Service Bulletin

Subject: Intuition Combustion Fan Wiring & Orientation

Models: Frymaster Intuition Gas Fryers

9/28/2026

Figure 1

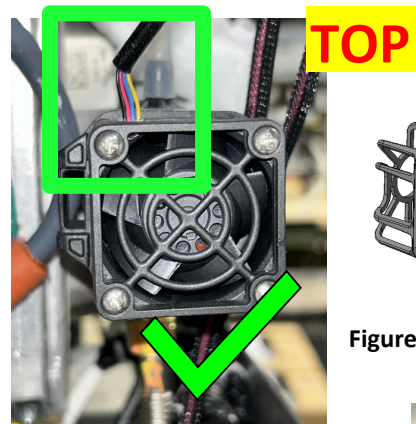
The combustion fan wires **SHOULD** be routed out the top of the combustion fan assembly (see Figures 1 and 2).

Remove the 4 (four) screws attaching the fan to the assembly and reorient the fan as shown in Figures 1 and 2, with the wires exiting the top of the fan.

Figure 3

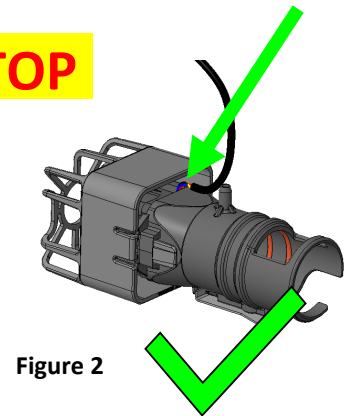
The wires **SHOULD NOT** be routed out the bottom or side of the assembly (see Figures 3 and 4), as this may allow the filter housing tabs to pinch and/or cut the wires (see Figures 5 and 6).
